# 3 Waters Report Waipā PPC20

Prepared for Waipā District Council Prepared by Beca Limited

### **20 February 2023**

Figure 2 - Existing and Proposed Water supply

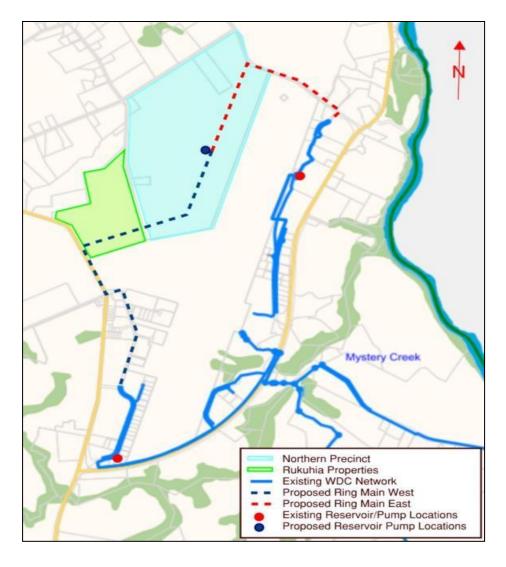
The bulk water to Titanium Park is currently supplied under agreement with WDC from their Pukerimu Scheme. It is proposed that the Northern Precinct can be supplied from the existing Titanium Park water network with the intention to ultimately ring main all precincts together, refer Figure 2.

It is proposed that the Northern Precinct would initially be supplied by a single supply line to its own reservoir and pump station, potentially on the elevated area within the Hub. This provides a lower resilience compared with a ring main supply, however, there are not likely to be essential services located within the development.

The original water supply agreement to the Airport Zone was based on 3 m³/Ha/day, which equates to a total daily demand for the entire airport zone (including the Northern Precinct) of 744 m³/day. This exceeds current agreed supply limit with WDC of 600 m³/day. Infrastructure upgrades in the Pukerimu scheme are planned once triggers are met to allow the 600 m³/day to be provided (as per current agreement).
